Seismic Evaluation Guidance

Augmented Approach for the Resolution of Fukushima Near-Term Task Force Recommendation 2.1: Seismic

Draft Report, January 2013

Figure 1-3
Detailed Flow Chart of the ESEP for the Augmented Approach

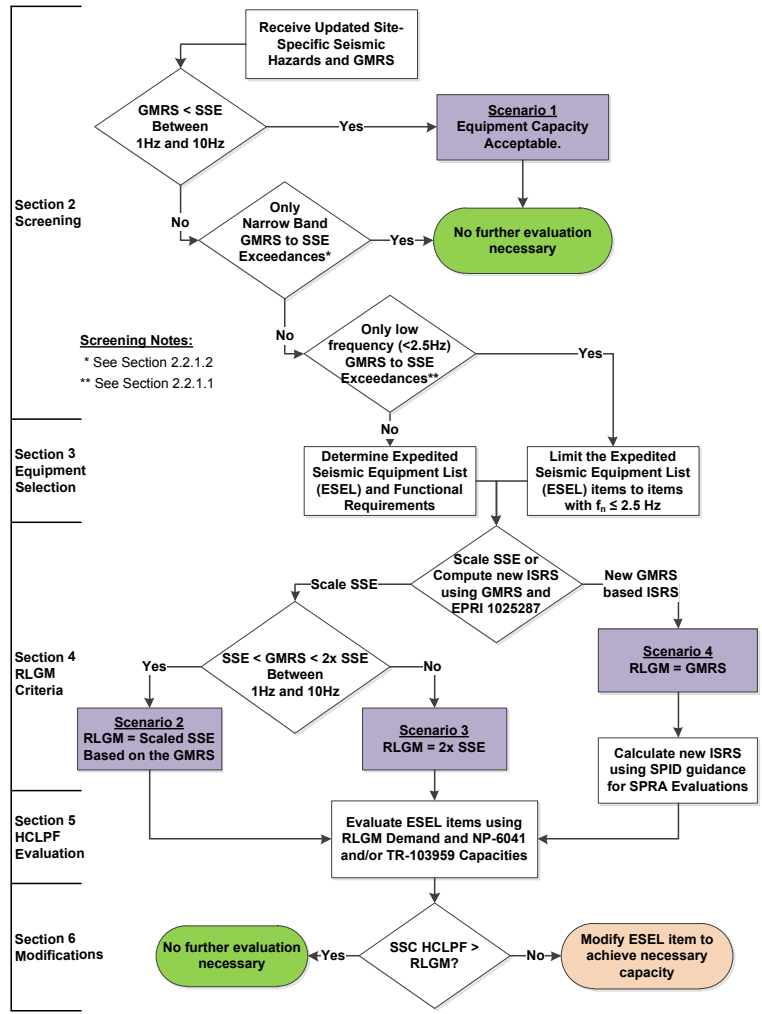
Comment [NRC5]: There were several comments during the public meeting on clarifying this and other flowcharts. The relationship to the SPID and the overall 50.54(f) request process needs to be clarified. For example, “No Further Evaluation Required” incorrectly implies the end of the process.

Figure 4-1
RLGM Generated by Scaling Up SSE Spectrum (Scenario 2 from Figure 1-3)

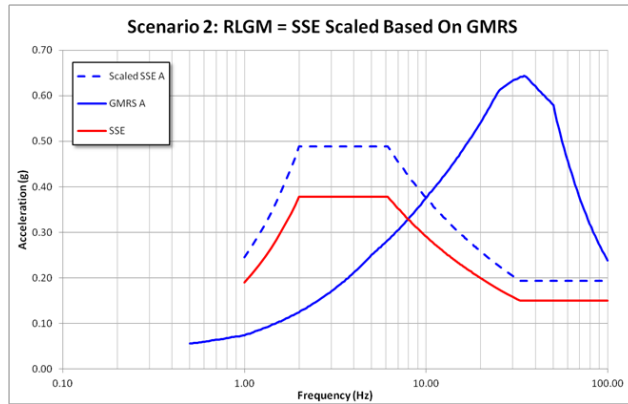
Comment [NRC15]: What is the relationship to the SPID criteria? Shouldn't this be in accordance with the SPID?
